ABOUT ADSP-BF542/BF544/BF547/BF548/BF549 SILICON ANOMALIES

These anomalies represent the currently known differences between revisions of the Blackfin® ADSP-BF542/BF544/BF547/BF548/BF549 product(s) and the functionality specified in the ADSP-BF542/BF544/BF547/BF548/BF549 data sheet(s) and the Hardware Reference book(s).

NR003403N

25. 05000457 - Host DMA Port Responds to Certain Bus Activity Without HOST_CE Assertion:

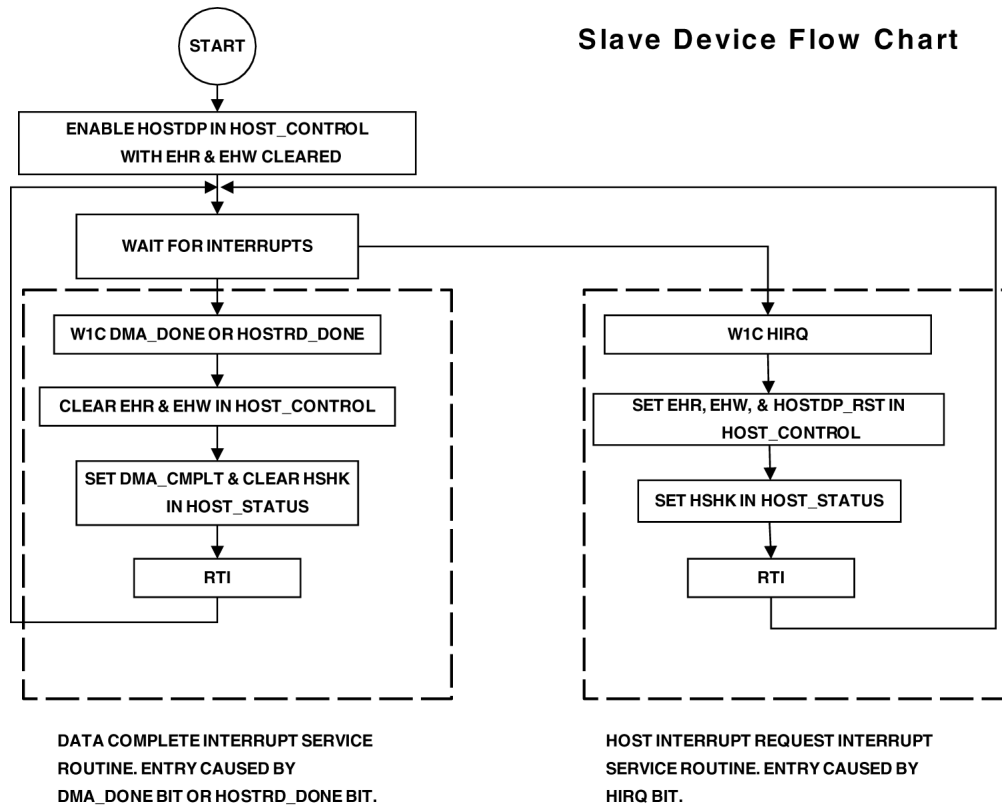
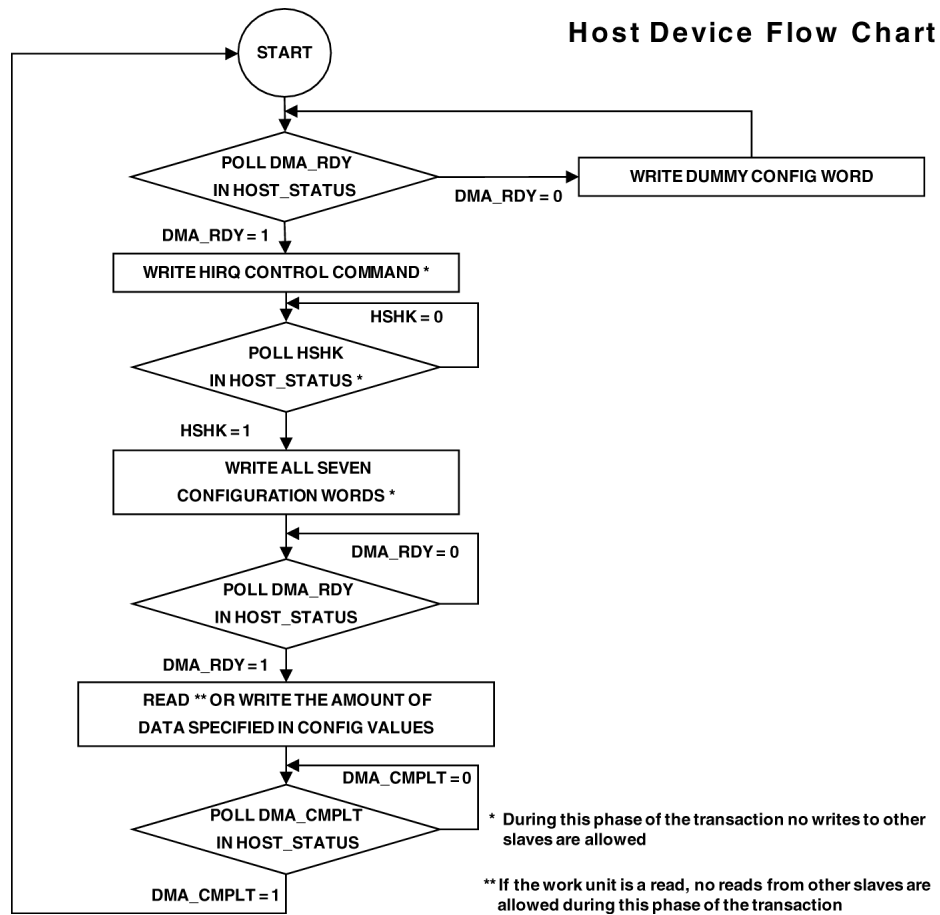
The Host DMA Port (HOSTDP) responds to certain bus activity even without the assertion of its chip enable, HOST_CE. If the HOSTDP is the only slave on the bus (meaning that HOST_WR and HOST_RD are asserted by the host only for communicating with the HOSTDP), this anomaly will not be observed. There are two states in which the HOSTDP responds to bus activity (assertion of HOST_WR or HOST_RD) without HOST_CE being asserted:

- 1) HOSTDP is Enabled and Waiting for the Host to Configure - While waiting for configuration in both acknowledge and interrupt modes, assertions of HOST_WR for other slaves can cause the HOSTDP to be erroneously configured.
- 2) HOSTDP is Configured for Data Reads - While waiting for data reads in both acknowledge and interrupt modes, assertions of HOST_RD for other slaves can cause the HOSTDP to subsequently return data out of order.

- 1) Add additional logic - Connect to HOST_WR through a 2-input OR gate where one input of the OR gate is the host's write signal and the other is the host's chip select.
- 2) Time bus accesses by the host processor - Do not write to other slaves on the bus between the time that the HOSTDP is enabled and the DMA_RDY bit in HOST_STATUS is set.
- 3) Change the software on both the host and the slave as shown in the following flowcharts:

- 1) Add additional logic - Connect to $\overline{\text{HOST_RD}}$ through a 2-input OR gate where one input of the OR gate is the host's read signal and the other is the host's chip select.
- 2) Time bus accesses by the host processor - Do not read from other slaves on the bus between the time that the final configuration word (YMODIFY) is written to the HOSTDP and the DMA_CMPLT bit in HOST_STATUS is set.
